### REPLIES TO BIDDER'S QUERIES

**PROJECT : Request for quotation for Shifting of steel gas pipe line at Ghobria Bawdi and Anantpura Circle**

**RFQ NO. : RSGL/KOTA/P-L Shifting/2020-21/ 28.08.2020**

**REINF. DETAIL OF VALVE PIT**

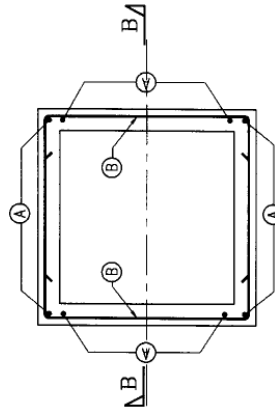
S.No.	Bidder Query	RSGL Replies
1	Payment terms are not mentioned in tender document. Activity wise part payments shall be provided to the contractor.	Payment terms : payment terms mentioned in clause 2.5 and GCC.
2	RCC Valve chamber drawing & dimension is not mentioned	RCC Drawing with dimensions is attached
3	Details of electrode to be used for welding and electrode testing is not mentioned. Can we use already approved electrodes of same batch number of other CGD company?	Yes, Approved electrodes of same batch no. of other CGD company can be use
4	Details about welder test details is not mentioned. Can we consider already approved WPS and qualified welders of other CGD company?	Yes, approved WPS and qualified welders can be use
5	Details regarding dismantling and reinstalling of any TCP/PCP TLP unit is not clarified. Does this work involve any work related to PCP / TCP system?	There is no involvement of TCP/PCP.
